UNITED STATES PATENT AND TRADEMARK OFFICE

APPLICATION NO.	FILING DATE	FIRST NAMED INVENTOR	ATTORNEY DOCKET NO.	CONFIRMATION NO.
10/799,201	03/12/2004	Jeoung-Mo Koo	8021-205 (SS-17942-US)	7424
22150	7590	06/27/2005	EXAMINER	
F. CHAU & ASSOCIATES, LLC 130 WOODBURY ROAD WOODBURY, NY 11797			ORTIZ, EDGARDO	
			ART UNIT	PAPER NUMBER
			2815

Office Action Summary

DETAILED ACTION

FIG. 3

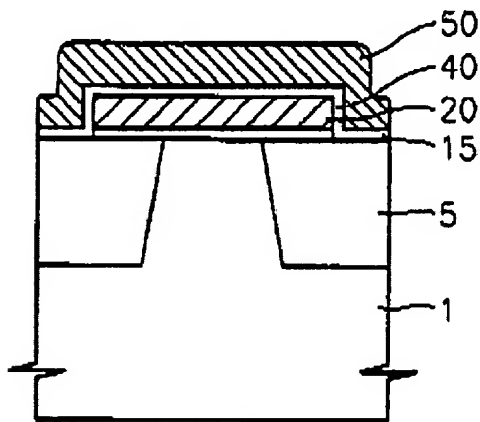
2. Figure 3 should be designated by a legend such as --Prior Art-- because only that which is old is illustrated. See MPEP § 608.02(g). Corrected drawings in compliance with 37 CFR 1.121(d) are required in reply to the Office action to avoid abandonment of the application. The replacement sheet(s) should be labeled "Replacement Sheet" in the page header (as per 37 CFR 1.84(c)) so as not to obstruct any portion of the drawing figures. If the changes are, not accepted by the examiner, the applicant will be notified and informed of any required corrective action in the next Office action. The objection to the drawings will not be held in abeyance.

With regard to Claim 5, Applicant's admitted prior art discloses a control gate (50) that is formed so as to enclose at least one sidewall of the floating gate (20). See figure 3.

FIG. 2K

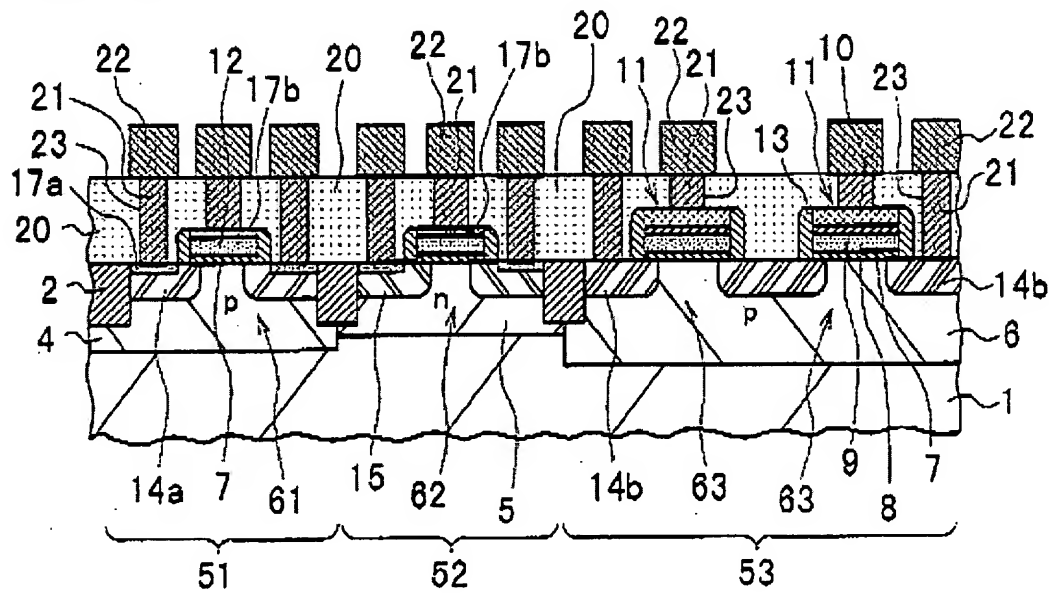
5. Claims 9 and 10 are rejected under 35 U.S.C. 102(b) as being anticipated by Matsubara (U.S. Patent No. 6,037,625). With regard to Claim 9, Matsubara discloses (column 1, lines 7-18 and figure 2K) an integrated circuit, comprising:

a memory device (region 53 column 9, line 2) including an isolation layer (2) which comprises an STI layer and defines an active area including source/drain regions (14b) of a substrate (1), a tunnel oxide layer (7), a floating gate (8) formed over the active area of the memory device and the isolation layer (2), inter-gate dielectric layer (9) formed on the floating gate (8), and a control gate (10) formed on the inter-gate dielectric layer (9);

a first transistor (see region 51) including a first gate (12), a first gate oxide layer (7) interposed between the first gate (12) and the substrate (1), the first source/drain regions (14a)

are formed in the active area at least one of under and adjacent both sides of the first gate (12);
and

a second transistor (see region 52) including a second gate (also labeled 12), a second gate oxide layer (also labeled 7) interposed between the second gate and the substrate (1) and second source/drain regions (15) are formed in the active area at least one of under and adjacent both sides of the first gate (also labeled 12).

With regard to Claim 10, Matsubara discloses a memory device (region 53) including source/drain regions (14b) formed in an active area at least one of under and adjacent both sides of the control gate (10).

FIG. 2

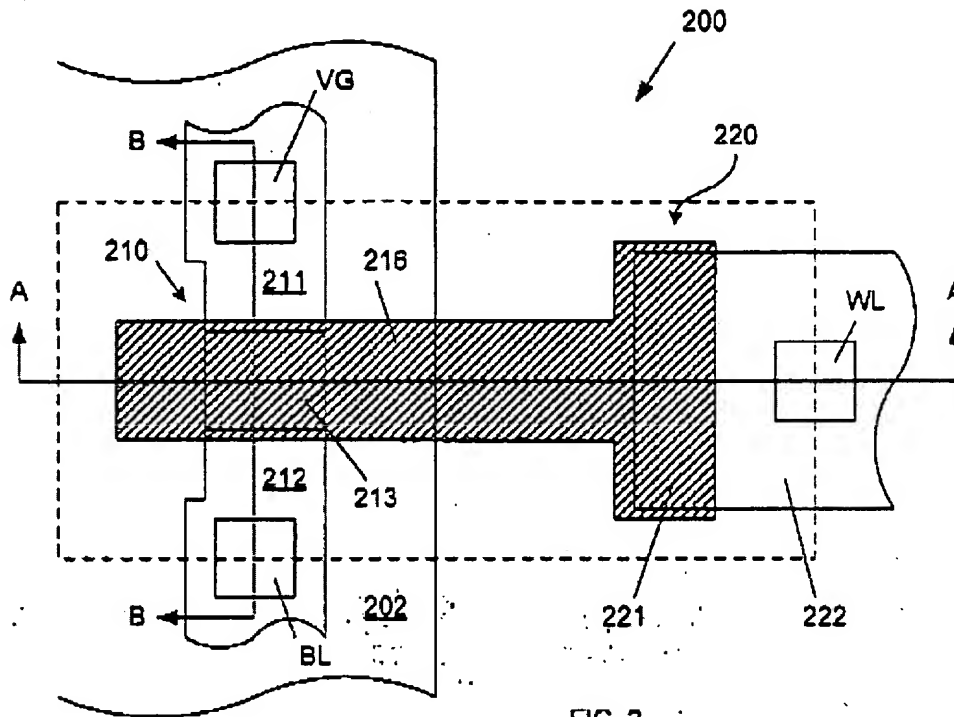
Claim 3 is rejected under 35 U.S.C. 103(a) as being unpatentable over Applicant's admitted prior art as disclosed on figures 1-3 and pages 1-2 of the instant application in view of Hsu (U.S. Patent Application Publication 2005/0074935). With regard to Claim 3, Applicant's admitted prior art essentially discloses the claimed invention but fails to disclose the claimed portion of the floating gate formed over the active area that is narrower than a portion of the floating gate formed over the isolation layer. However, Hsu discloses (figure 2) a memory cell (200), which includes a floating gate (216) having a portion over an active region defined by source region (211) and drain region (212) that is narrower than the portion of the floating gate that is not over the active region, namely the portion outside region (202):

Therefore, it would have been obvious to someone with ordinary skill in the art, at the time of the invention, to modify the structure as disclosed by Applicant's admitted prior art to include the claimed portion of the floating gate formed over the active area that is narrower than a portion of the floating gate formed over the isolation layer, as suggested by Hsu, in order to facilitate the formation of a contact hole to the floating gate by forming said contact hole in the wider portion.

FIG. 16

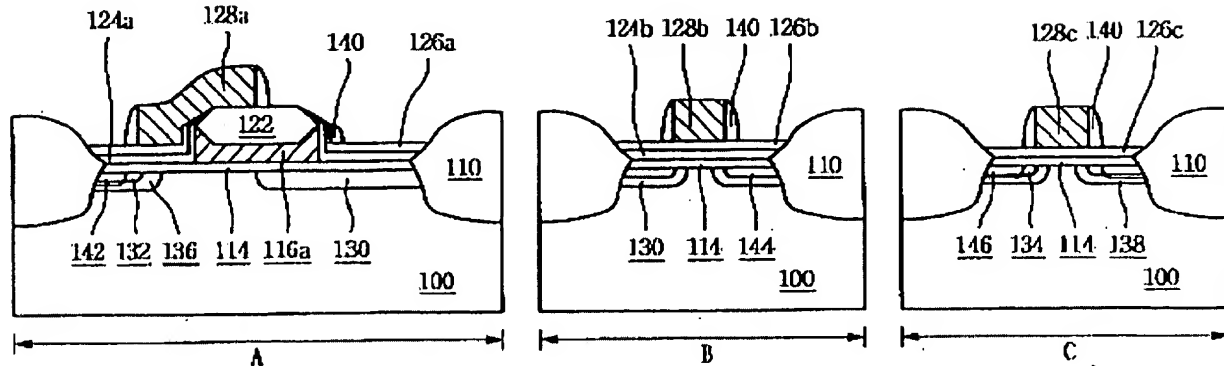
8. Claims 11, 14 -16 are rejected under 35 U.S.C. 103(a) as being unpatentable over Matsubara et al. (U.S. Patent No. 6,037, 625) in view of Lee (U.S. Patent No. 6,348,378). With regard to Claim 11, Matsubara essentially discloses the claimed invention but fails to disclose the claimed second gate oxide layer being thinner than the first gate oxide layer. However, Lee discloses a semiconductor device including a memory device (region A of substrate 100) and transistors (defined by regions B and C of substrate 100), wherein the gate oxide (defined by layers 114 and 126b) of the transistor of region C is thinner than the gate oxide (defined by layers 114, 124b, 126c) of the transistor of region B, as clearly shown on figure 16 and included herein.

Therefore, it would have been obvious to someone with ordinary skill in the art, at the time of the invention, to modify the structure as disclosed by Matsubara to include the claimed second gate oxide layer being thinner than the first gate oxide layer, as suggested by Lee, in order to provide gate oxide layers with different thickness for high and low voltage transistors (column 9, lines 65-67 and column 10, lines 1-4).
